**CALIFORNIA COASTAL COMMISSION**

**STAFF REPORT:  
REVISED FINDINGS FOR AMENDMENT**

**APPLICATION NUMBER: 3-96-008-A1**

**PROJECT LOCATION: 921 Pigeon Point Road (adjacent to the Pigeon Point Lighthouse),  
Pescadero, San Mateo County**

11 RECIRCULATING SANDFILTER

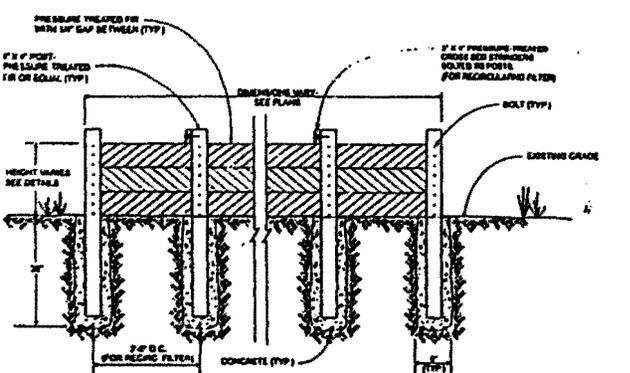
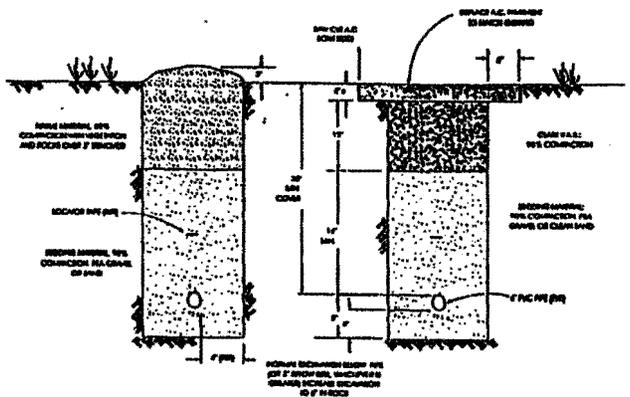
western fence) and will not block ocean views. According to the project engineer, the top surface of the sand filter will be finished with gravel or sand and may be planted with drought tolerant container plants, further minimizing its visual impact.

- **Sand Filter.** The sand filter will be the only part of the sanitary wastewater system that will extend above ground surface. As shown on Sheet 3 of the enclosed drawings, the sand filter will be constructed partially above and partially below grade. It will be supported above grade with a low wood retaining wall, approximately 42 inches high. The overall plan dimensions of the sand filter are approximately 16 feet by 22 feet. The surface of the sand filter will be finished with rounded river rock, gravel, or sand, and it may be planted with low maintenance, drought tolerant vegetation or container plants.

EXHIBIT NO. G
APPLICATION NO. A-3-SMC-96-03
McKENZIE
Storage Building

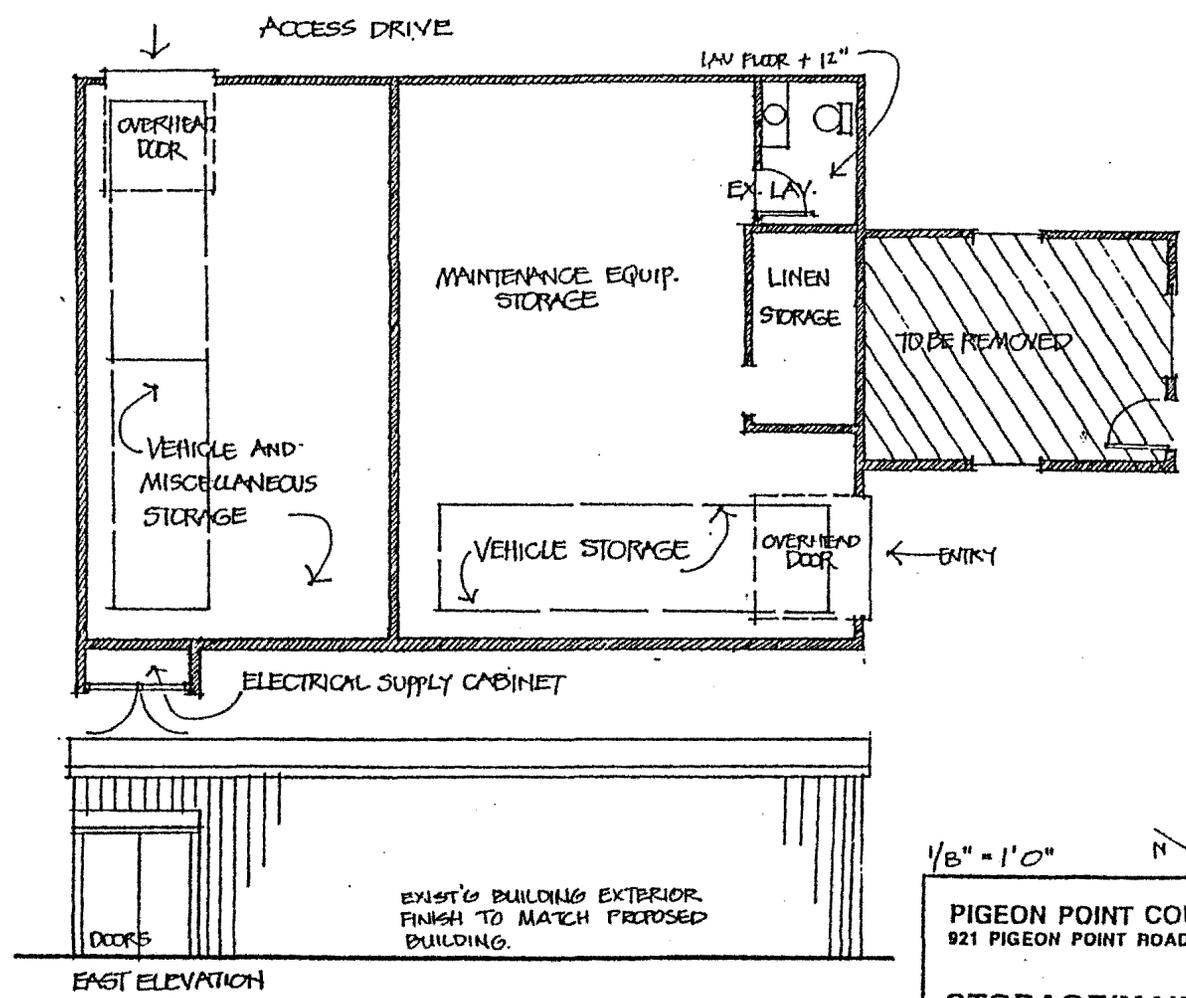
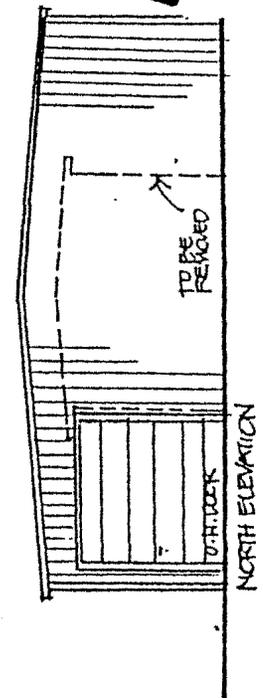
Plans for the storage unit submitted with the amendment do not, however, show the reverse osmosis unit within the building, or the placement of the pump control and alarm system on the exterior of the building. To confirm that the reverse osmosis unit will be located within this building, and that the pump controls and alarm system will be located on the exterior of this building in a visually unobtrusive and architecturally compatible manner, Special Condition 5.b. requires the applicant to submit final plans for the storage building that identifies these features, for Executive Director review and approval.

Special Condition 5.b. also requires that final plans for the storage building illustrate the design, dimensions, and materials of the siding that will be used to screen the 6,000 gallon above ground water tank. To ensure that the proposed screening is architecturally compatible with the surrounding structures, as called for by LCP Policy 8.13d, Special Condition 5.b. specifies that the siding shall match the siding of the remodeled storage building, and that neither the tank nor the siding shall exceed a height of twelve feet. The use of siding rather than native vegetation is consistent with LCP Visual Resource Policies because it will provide equal or superior screening of the water tank. A fence will not require time to mature so that the tank is completely screened, and it will have a narrower and shorter profile over the long term than trees which, once mature, could potentially obstruct views of the lighthouse or ocean.

b. **Revised Storage Building Plans.** Final plans for the remodeled storage building shall: identify the location of the reverse osmosis treatment facility within the building; indicate the size and location of the pump controls and infrastructure alarm system on the western exterior of the storage building; and, shall illustrate the design, dimensions, and materials of the wood siding that will be used to screen the 6,000 gallon water storage tank shown in the sewage disposal plan prepared by Questa Engineering Corporation (as revised on 8/10/98). To ensure architectural compatibility, the wood siding used to screen the water storage tank shall match the siding of the remodeled storage building, and neither the tank nor the wood siding shall exceed a height of 12 feet above ground surface. The permittee is responsible for maintaining the wood siding throughout the lifetime of the project in a manner which effectively screens the water tank, in its entirety, from public view.
